Reviewed and Accepted
LAKE COUNTY GENERAL HEALTH DISTRICT
Date 9.10.92
See conditions
JOEL LUCIA, R.S., M.P.H.
Health Commissioner
BY Nancy Nerio

Grading Plan Approved as shown and/or noted
THOMAS P. GILLES, P.E.
Lake County Engineer
By GJA Date 8/7/92

SITE PLAN FOR: FAYER
LANE ROAD LAKE COUNTY PERRY, OHIO

TYPICAL LEACHING TRENCH CROSS SECTION

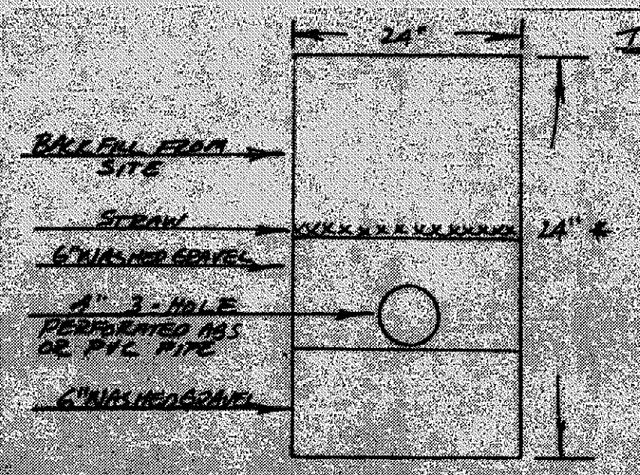
① The system will be very tight!
② The leach lines must be installed at a min/max of 18". No more!
③ The house may have to be elevated or a sewage effluent pump installed
④ The curtain drain must be 6" deeper than

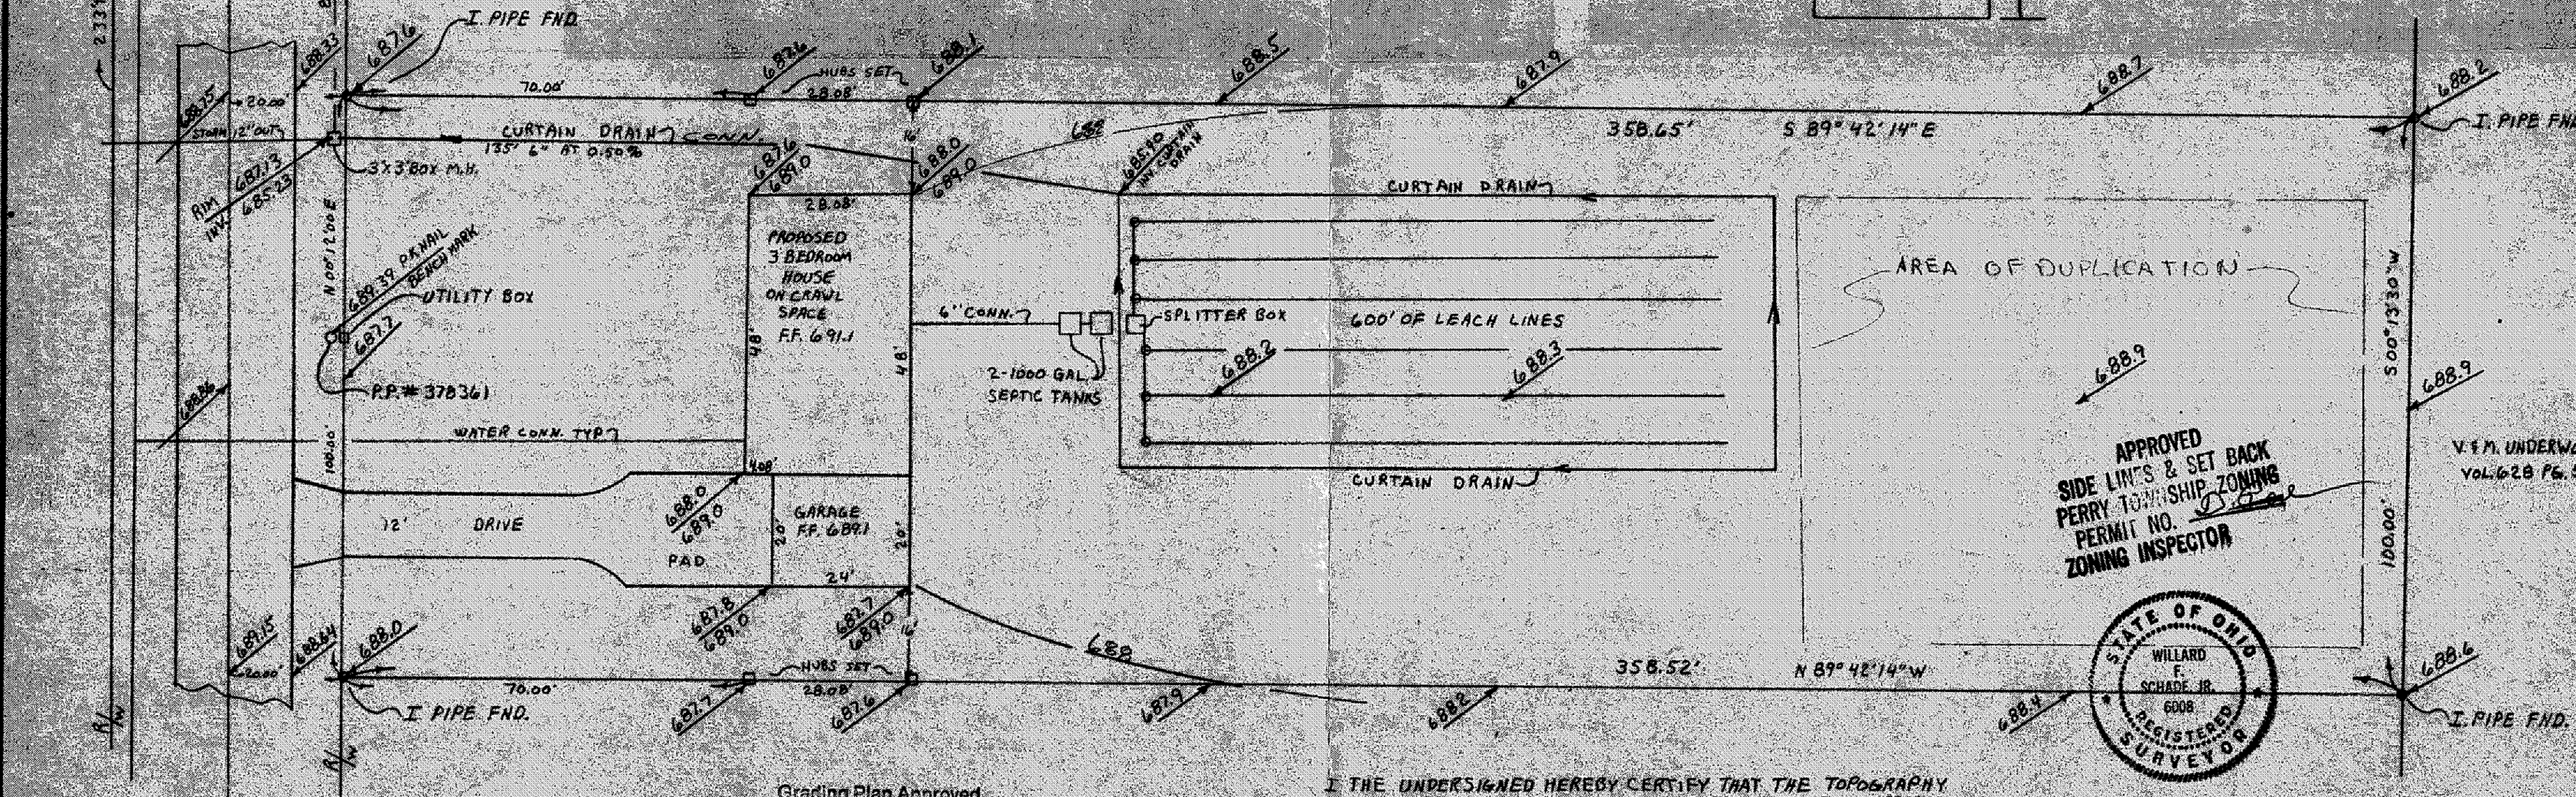
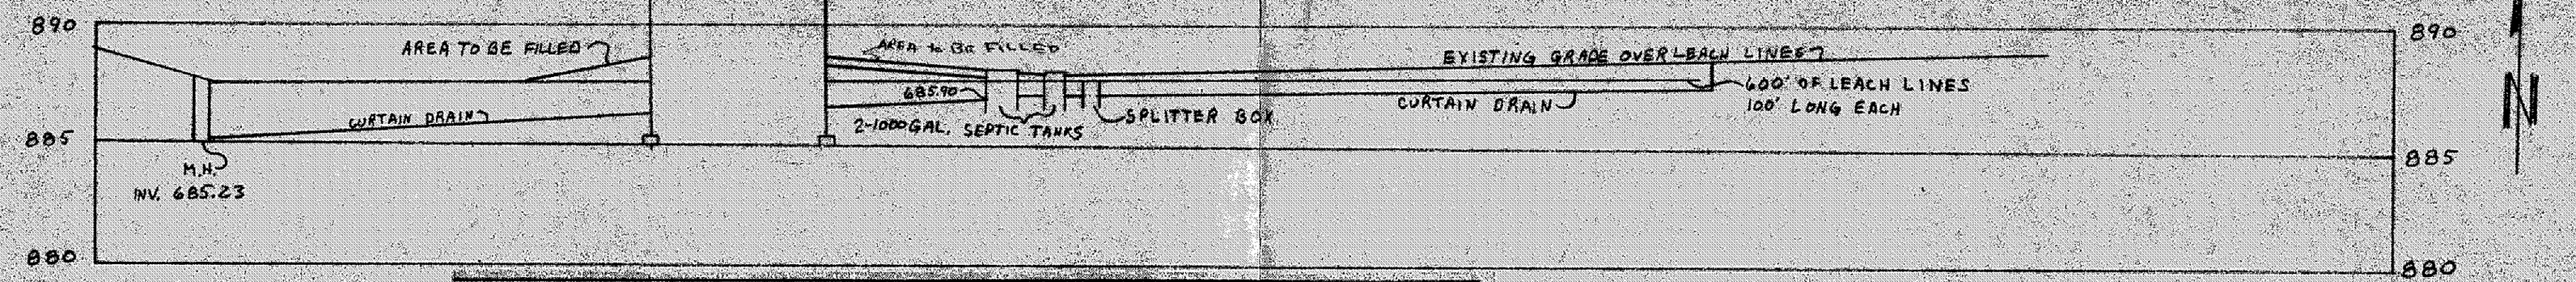
Conditions
